Access Compliance Report Public Rights-of-Way (Curb Ramps)

Main Street: ACECA_DR Cross Street: NEWBURY_RD Location: NW

ADA ID: RPRK211216133241 Ramp Type: Type 1 - Perpendicular Diagonal Initial Pass/Fail: Pass Overall Compliance: No Severity Score: 10

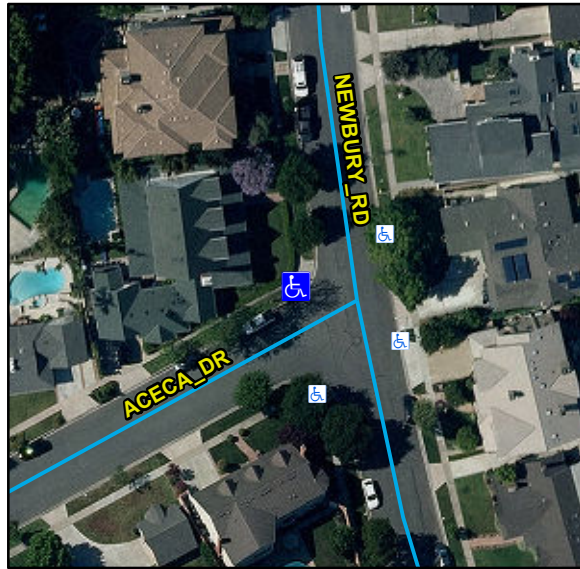
Compliance	Description	Data	Compliance	Description	Data
N/A	Ramp Length (in)	84	N/A	Flare Type LT	
Yes	Ramp Width (in)	48			Sloped
Yes	Ramp Run Slope (%)	8.3	N/A	Flare Slope LT (%)	5.5
Yes	Ramp Cross Slope (%)	0.1	N/A	Flare Traversable LT	No
N/A	Landing Present	Yes	N/A	Flare Type RT	
N/A	Landing Length (in)	47			Sloped
Yes	Landing Width (in)	48	N/A	Flare Slope RT (%)	4.4
No	Landing Run Slope (%)	2.7	N/A	Flare Traversable RT	No
Yes	Landing Cross Slope (%)	1	Yes	DWS Provided	Yes
N/A	Landing Movement Obstructed?	Yes	Yes	DWS Contrast	Yes
	Landing Movement Type	Bushes	Yes	DWS Length (in)	36
N/A	Landing Shared	No	Yes	DWS Full Width	Yes
N/A	Clear Space	Yes	Yes	DWS Offset Left (in)	0
N/A	Clear Space To Crosswalk (in)	48	Yes	DWS Offset Right (in)	N/A
N/A	Marked Crosswalk 1	No	N/A	Marked Crosswalk 2	No
	Crossing 1 Direction	S		Crossing 2 Direction	E
	Marked Crosswalk 1 Width (in)	N/A		Marked Crosswalk 2 Width (in)	N/A

N/A	Ramp Inside Crosswalk 1	N/A	Yes	Ramp Inside Crosswalk 2	N/A
	Crossing 1 Slope (%)	3.7		Crossing 2 Slope (%)	7.4
	Crossing 1 Cross Slope (%)	0.7		Crossing 2 Cross Slope (%)	0.4
No	Gutter Ponding	Yes	Yes	Curb Slope	1.7
Yes	Gutter Lip Height (in)	0		Road Run Slope (%)	1.9
No	Gutter Run Slope (%)	7.2		Road Cross Slope (%)	7.5
Yes	Gutter Cross Slope (%)	0.6			
Yes	Overall Surface Condition: Acceptable		Yes	Perp Joint Present	Yes
	Cross Gutter Present?	No		Spandrel Present?	No
	Replace Cross Gutter?	N/A		Replace Spandrel?	N/A

Remove & Replace Landing. Remove & Replace Gutter.

R304.2.1, R304.2.2-Perp, R304.3.2-Para, R302.7, R304.5.4, STD 1115
